HANNEY & ASSOCIATES ARCHITECTS
1726 South Hillside, Wichita, Kansas

NOTICE TO BIDDERS

You are hereby instructed to include in your bids the following changes and/or corrections to the Drawings and Specifications for the Fine Arts Addition to Andale High School, Andale, Kansas.

S0.1

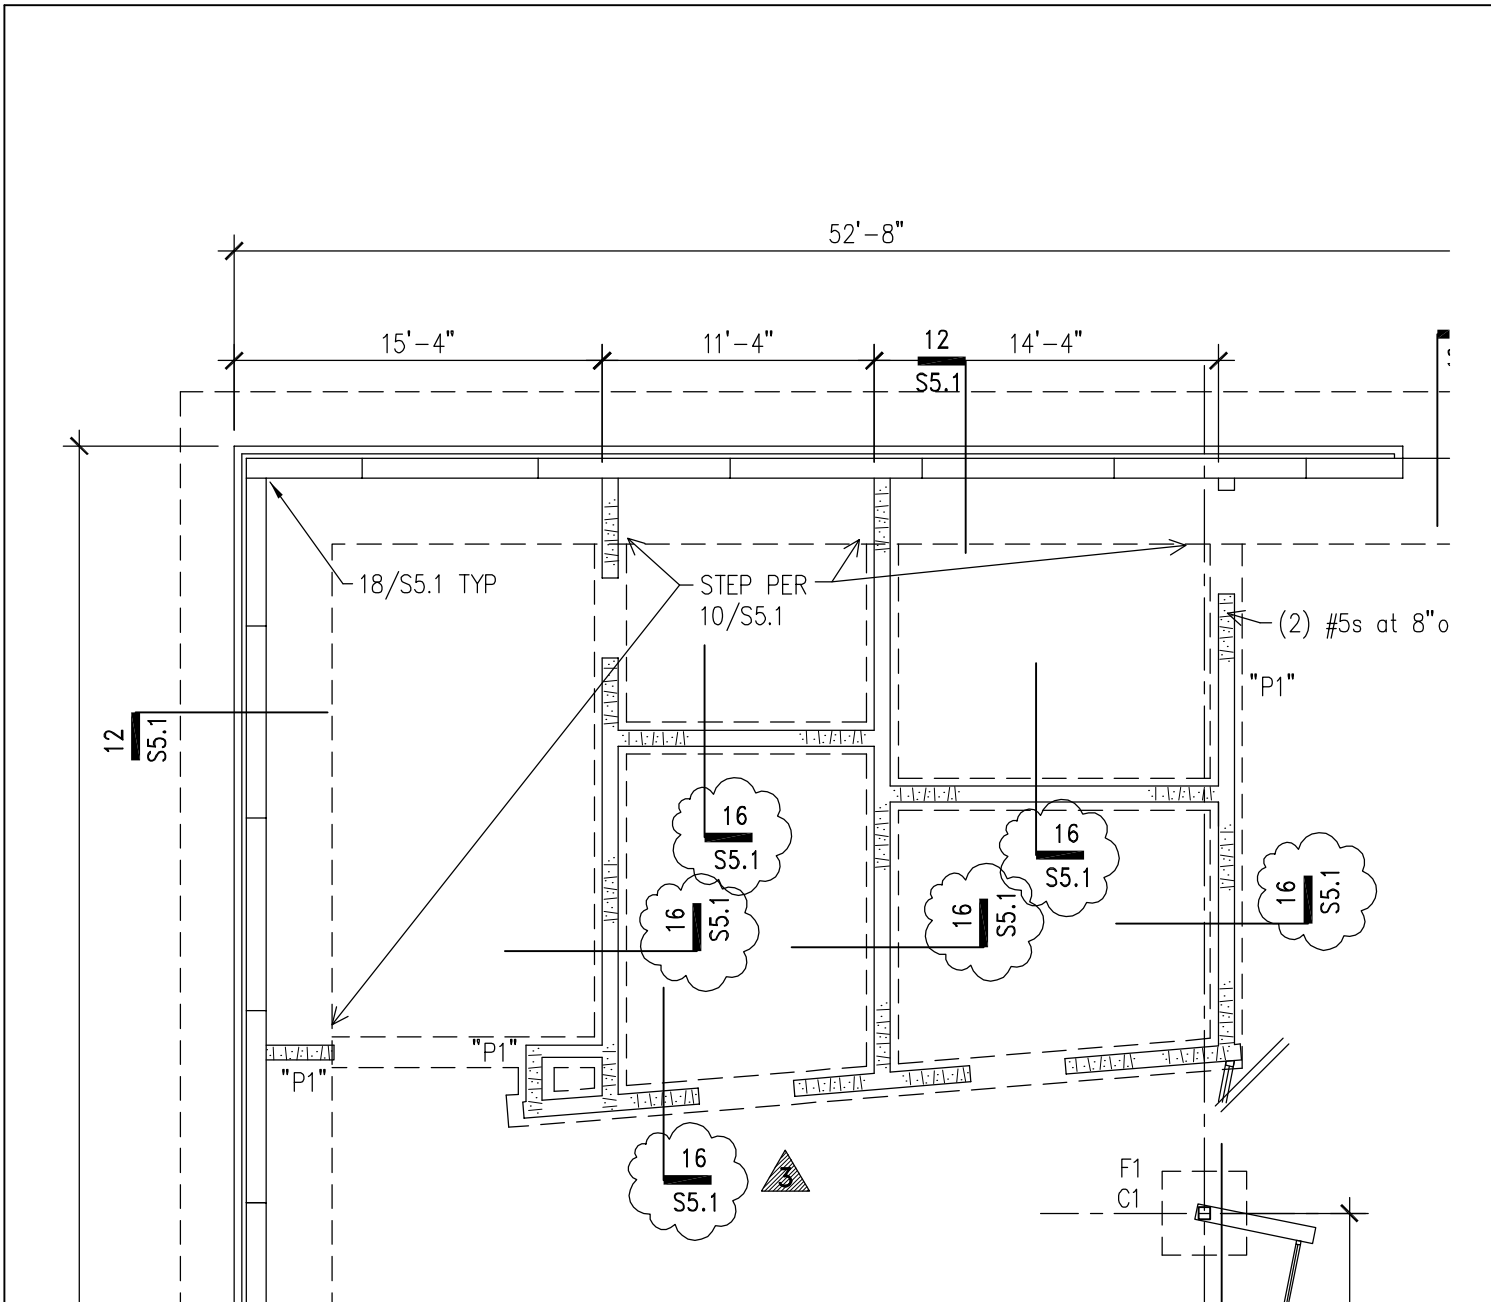
- 2.10 Sheet A4.3
2.10.1 Elevation “A”, there are two wall section indicators that reference sheet A5.12. The detail on the far left shall be changed to be detail 2/A4.7 referencing the banners. The next detail bubble shall be deleted.
- 2.11 The Structural Engineer is issuing an 8-1/2” x 11” clarification to both to Sheets S0.1 and S2.1. These are included at the end of this addendum.

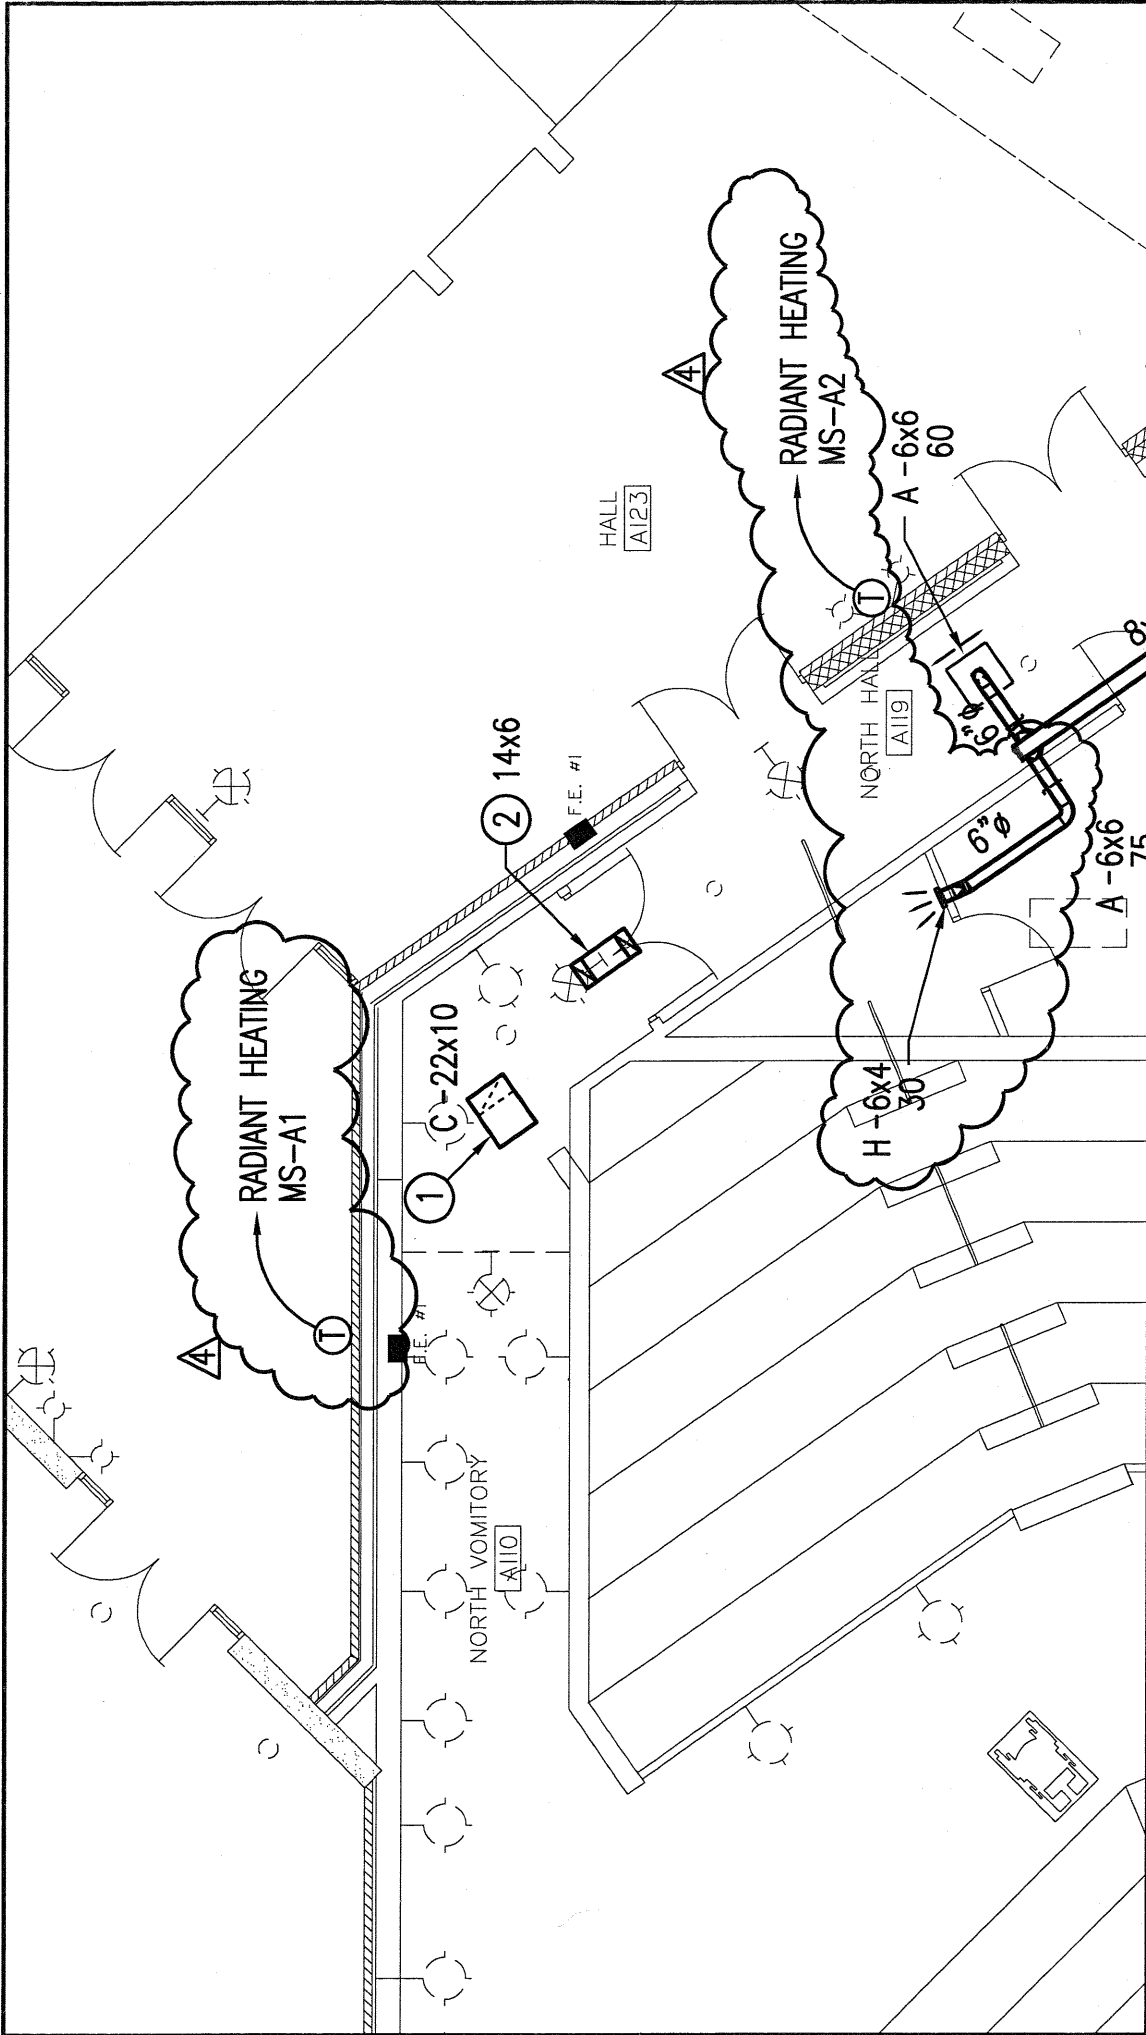
- 3.9 Specifications Section 15440, Plumbing Fixtures, Item 1.2, B Approved Manufacturer’s: Replace Eljer with Zurn under China Fixture Manufacturers.
- 3.10 Drawing Sheet M2.1, HVAC Plan – Lower Level:
 - 3.10.1 Change the diffuser in Stage Entry A109 from a Mark ‘A’ to a Mark ‘B’. Mount diffuser at approximate elevation 128’-0”.
 - 3.10.2 See enclosed partial revised plan.
- 3.11 Drawing Sheet M2.2: See the revised drawing.
- 3.12 Drawing Sheet M2.3: See the revised drawing.
- 3.13 Drawing Sheet M4.2:
 - 3.13.1 Grille & Register Schedule: Mark ‘H’ Supply Grill is to be a Model 272-FL in lieu of 272-FS.
 - 3.13.2 Plumbing Fixture Schedule: Change Fixture P4.1, Washsink in the Plumbing Fixture List to the following:

ANDALE HIGH SCHOOL	
RENWICK UNIFIED SCHOOL DISTRICT 267	
E2.3 ELECTRICAL POWER PLAN - ALTERNATE #1	
JOB NUMBER:	08004-001
DATE:	03/25/09
SCALE:	1/8" = 1'-0"
DRAWN BY:	JLM
CHECKED BY:	DLD
SHEET NUMBER:	1 OF 1

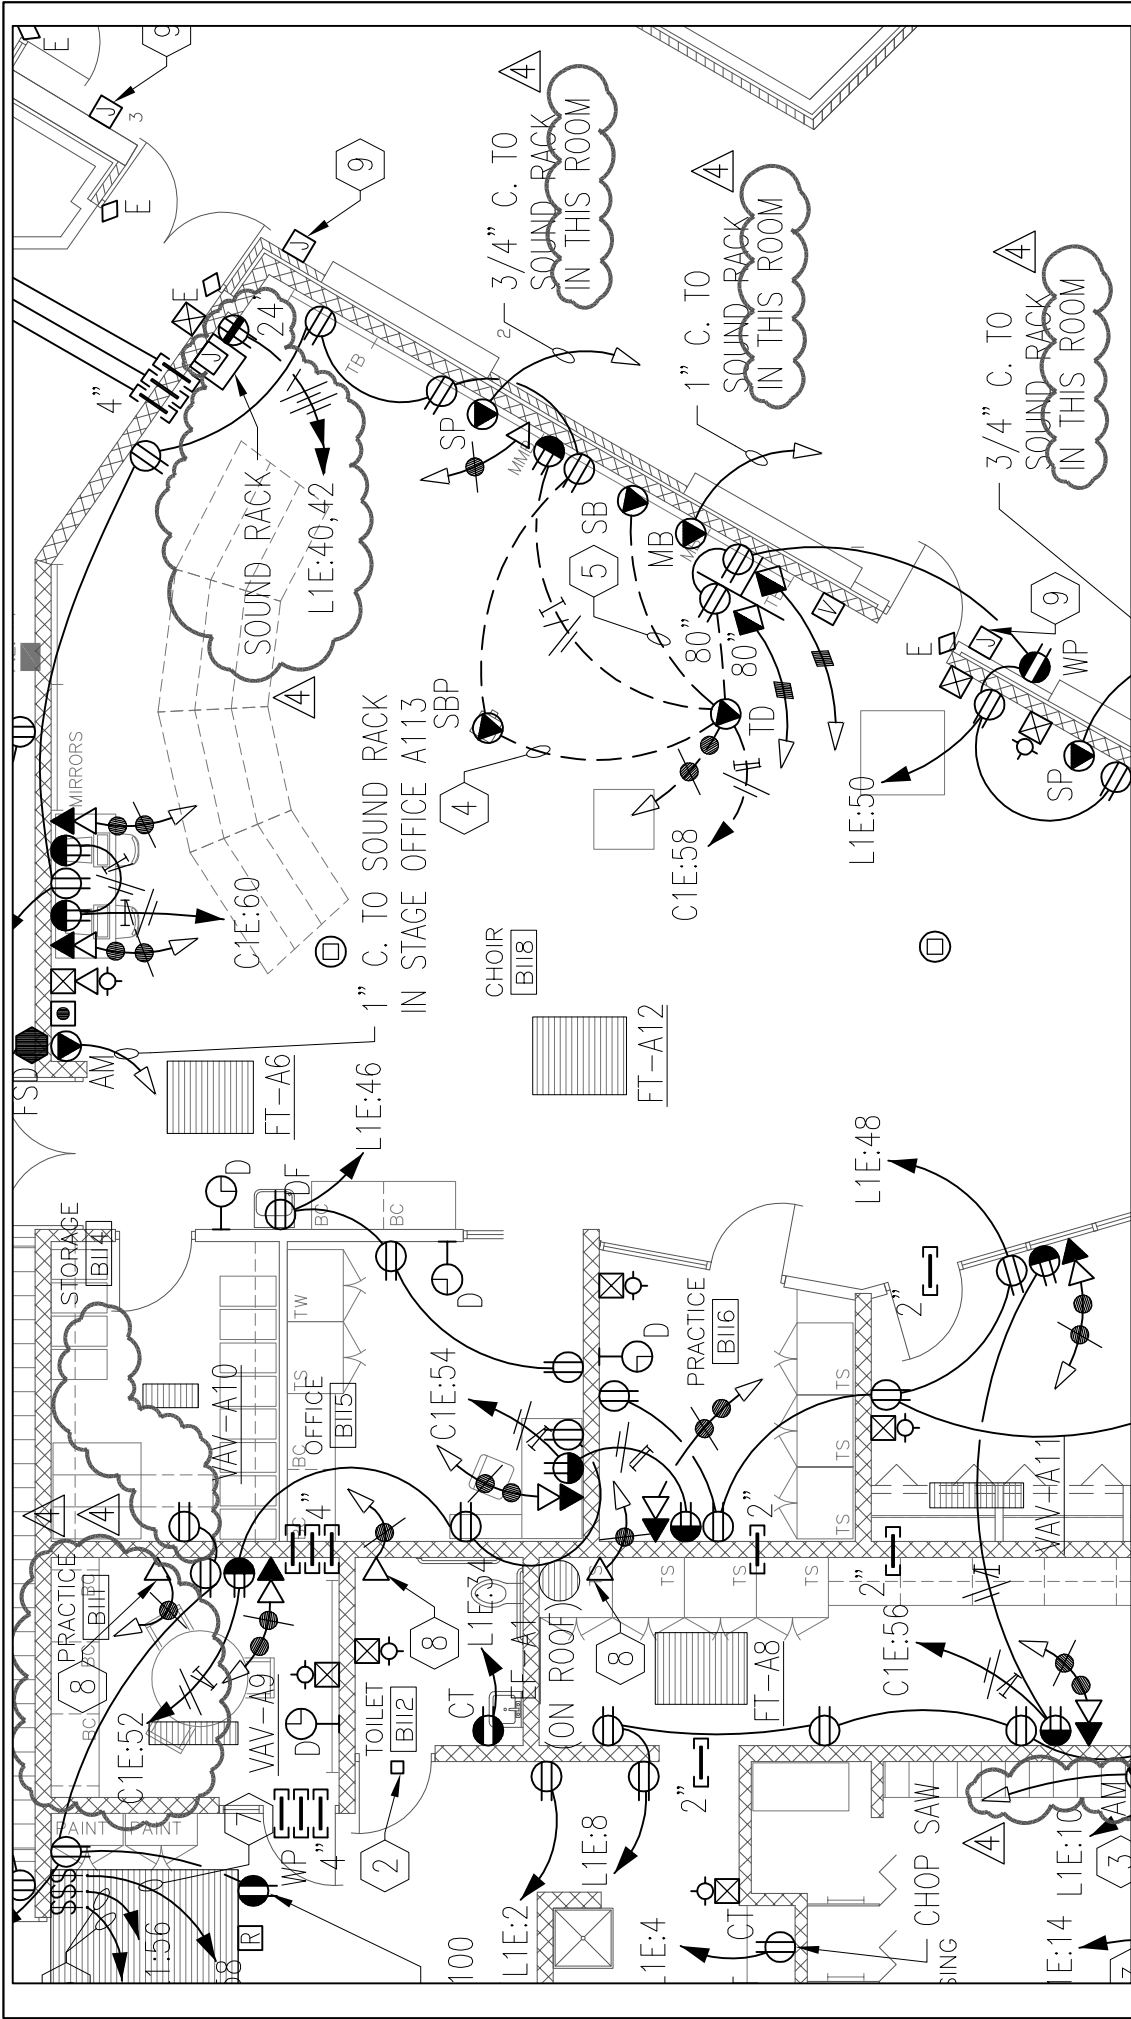
- 3.21.5 Drama/Stagecraft B106 on sheet E2.2: New wall telephone outlet on north wall.
- 3.22 Relocate sound rack and associated receptacle and wiring from Storage B114 to Choir B118. Mount junction box at 4’-6” AFF for connection of conduit from speakers and microphone. Mount receptacle at 24” AFF. All references to conduit run to the sound rack in Storage B114 shall be changed to new location in Choir B118. Add receptacle in Storage B114 and connect to circuit L1E:44. See sheet E2.3 attached.

- 3.39 Add circuit L1E:106 to panel L1E on sheet E1.5. Provide 20A, 120V, 1P. breaker. Circuit shall be labeled "BOY'S DRESSING B110 VANITY LTG".
- 3.40 Delete receptacles and data/telephone outlet and associate wiring on north wall of Practice B111 on sheet E2.3 to coordinate with cabinetry. See attached sheet E2.3.
